SUBJECT: Response to Questions on Generic Letter 96-06

Enclosed are responses to questions raised on the document "Resolution of Generic Letter 96-06 Waterhammer Issues", EPRI Interim Report TR-113594--V1 & V2, December 2000. We have previously transmitted revisions to Section 5.2.2 and 5.2.3 of Volume 1 (User's Manual) and Sections 6 and 8 of Volume 2 (the Technical Basis Report). The other sections of the report are essentially unchanged from the earlier transmittal and will only have editorial changes made prior to final submittal. The attachment to this letter includes responses to specific questions raised by the NRC. This information will be addressed as applicable in the final revision to the Technical Basis Report.

Figure 13-7: Trapezoid Characterization/Actual Data Comparison (44 Tests)

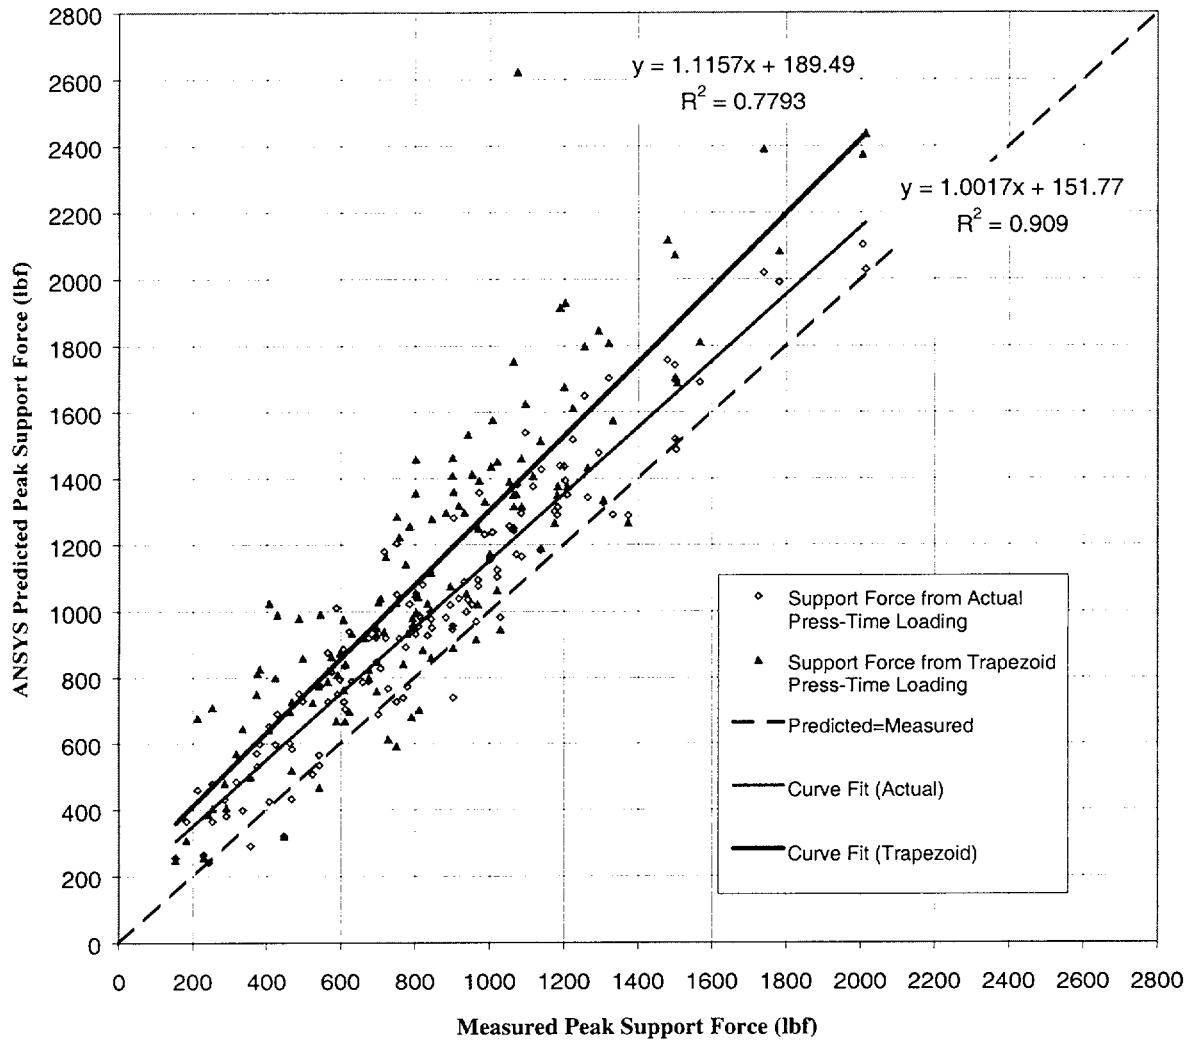
- 1. The rigid body model involves defining the waterhammer pulse as a trapezoid function having a recommended rise time. However, the recommended method for choosing rise times does not appear to be conservative when considering the steepest part of the pressure-time data plots. Also, the pulse duration is recommended to be lengthened by a factor to preserve the area under the trapezoid shape. However, this also does not appear to be conservative since it could result in less structural response than for the actually expected duration.**

The effectiveness of the trapezoid model was tested by comparing the response of an ANSYS model with loading from the idealized trapezoids and loading with actual pressure-time histories to the measured force response from the tests. Support loads at three locations were measured in the tests. A set of 44 test measured pressure traces from the tests was used as the "actual" pressure-time input. The test traces were accurately input to ANSYS in detail. These pulses were also characterized as trapezoids using the methods recommended in the User's Manual and then used to load the ANSYS model. The results of these two load sets (idealized trapezoid versus the actual pressure history) compared to the support forces measured in the tests is provided below (Figure 13-7 of

the TBR). Most data fell above the “predicted = measured” line at 45° in the figure. The points that fell below the 45° line were a small percentage of the total and these points were located close to the line.

These two comparisons show that both the actual pressure trace and the trapezoidal representation provide accurate methods to capture the response of the structure when compared to the test data. Figures 13-7 and 13-8 further show that the “curve fit” for the trapezoidal pulses provide a prediction of a higher support load than the actual pressure pulse. This indicates that on average, the trapezoidal pressure pulse is more conservative. The statistical nature of the testing, particularly for events like waterhammer, does provide a small number of calculated loads that are lower than the test results. The number of calculated points that fall below the test data is considered to be typical of what would be expected for this number of tests for a phenomena that has as much scatter as waterhammer testing.

On average, the analysis with the actual pressure time loading is conservative versus the test data by approximately 15% (percentage calculated at a load of 1,000 pounds) and the analysis with the trapezoidal pressure time loading is conservative versus the test data by approximately 30%. The trends from Figure 13-8 are the same.

Figure 13-8: Trapezoid Characterization (All Tests)

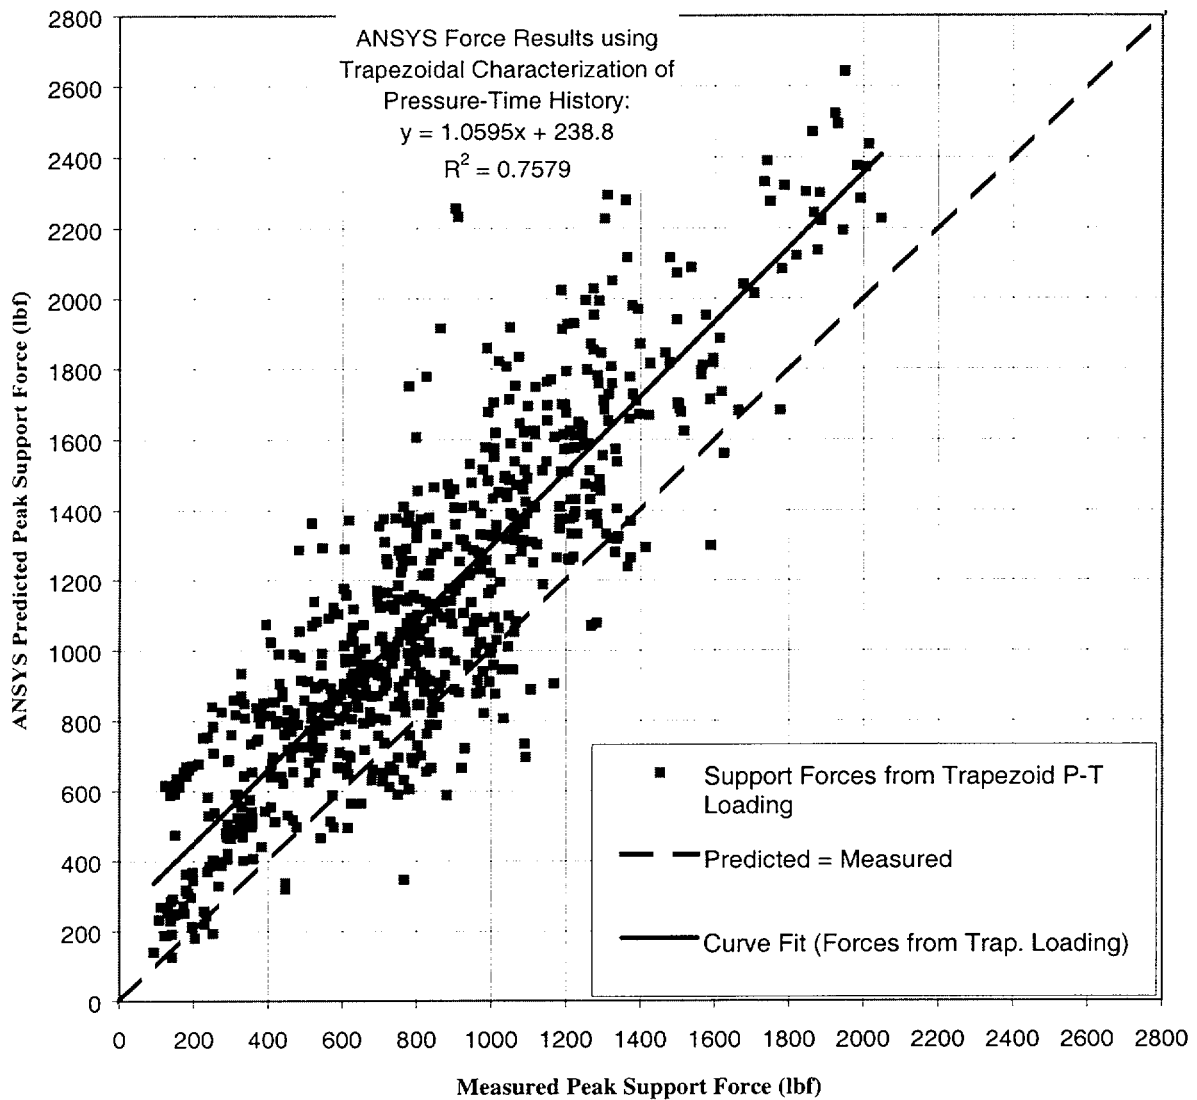
2. The report recommends using only one waterhammer pulse in evaluating system piping. However, waterhammer pressure loads are composed of several reversing cyclic pulses (Examples are shown in Figures 5-3 and 7-3). Figure 13-8 indicates that for the test configuration, the use of a single trapezoidal pulse is conservative in most cases evaluated. However, there are a few cases shown where this method is not conservative. Also, the structural and forcing function frequencies for plant piping configurations will differ from the tests. Therefore, a longer pressure history involving several cycles

Figure 13-8 in the TBR, also provided below, showed the results for the trapezoidal characterization of the pulses for all tests analyzed using the same ANSYS model. These force responses are plotted versus the measured force data for all three restraints (F1, F2, and F3). The 45° dashed line (predicted = measured) represents exact matching of the measured response. This plot further demonstrates the accuracy of the trapezoidal modeling technique as a means of predicting real support forces.

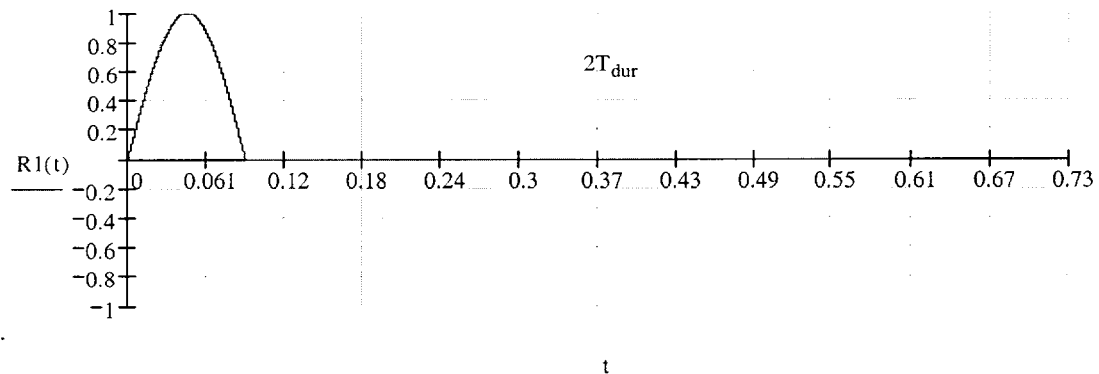
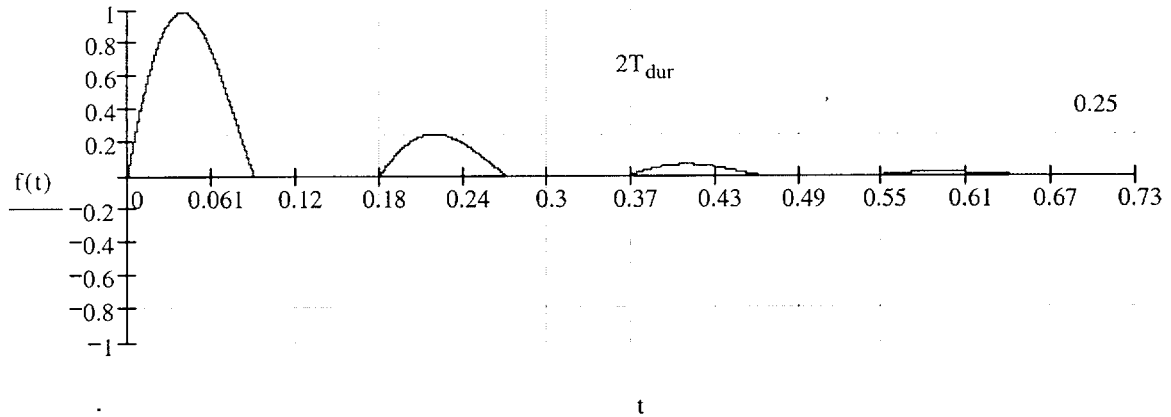
should be included in analysis of plant piping systems since this could result in additional energy being added to the structures.

The column closure event is essentially a single pulse phenomenon. Any subsequent pressure pulse after the initial pressure rise is caused by reflected waves passing through the system. The reflected waves will be significantly smaller in magnitude than the initial pulse.

To investigate the accuracy of using a single pulse, a single degree of freedom model was selected as typical of a single segment of piping that experiences an axial load caused by a passing pressure wave. This model was loaded with a repeating, decaying pressure pulse that occurs at the precise natural frequency of the structure. This was compared to a single pressure pulse load of the same initial duration. The degree of decay from the first peak to the second peak was approximately 75% as would be expected with a reflected wave and as was seen in Figure 5-3 of the TBR. The two loads are provided in the following figures.

Using 2% damping, the resulting displacements for the multiple loading are within 10% of that produced by a single load. This was for the case where the loading frequency was precisely equal to the natural frequency of the system.

Figure 10-8: Rise Time vs. Impact Velocity – Configuration 1, 2a, and 2b

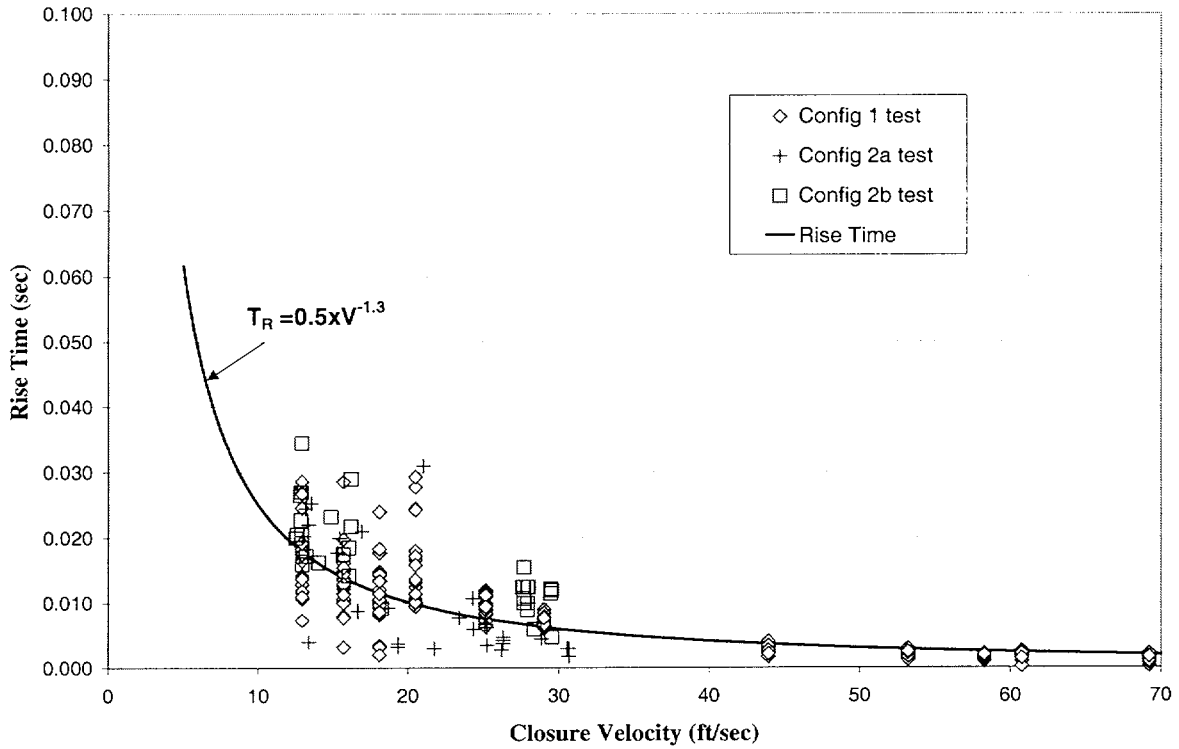
- 1. The relationship of pressure rise time to impact velocity is given only for test configuration No. 1 which did not include air in the steam void. Please provide a comparison of the pressure rise time relationship with the data from test configuration 2 which did include air.**

The individual rise times for the Configuration 2a and 2b tests have been calculated. This data is provided in Figure 10-8, attached. This figure also includes the Configuration 1 test results. The comparison shows that the rise times for Configuration 2a and 2b tests are similar to the rise times for Configuration 1 when the closure velocities are similar.

Figure 10-9: Configuration 2a and 2b Peak Pressure vs. Closure Velocity

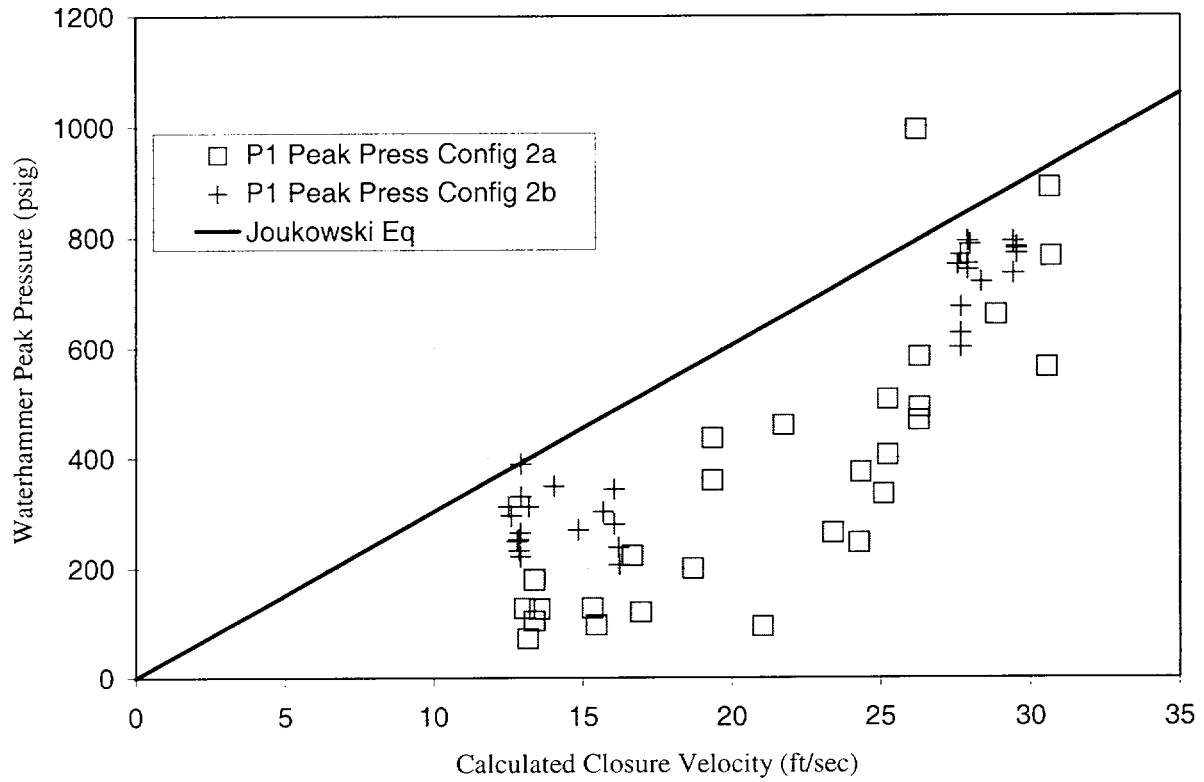
- 2. Please provide figure 10-9 which was missing from the "Technical Basis Report".**

A copy of Figure 10-9 is attached.
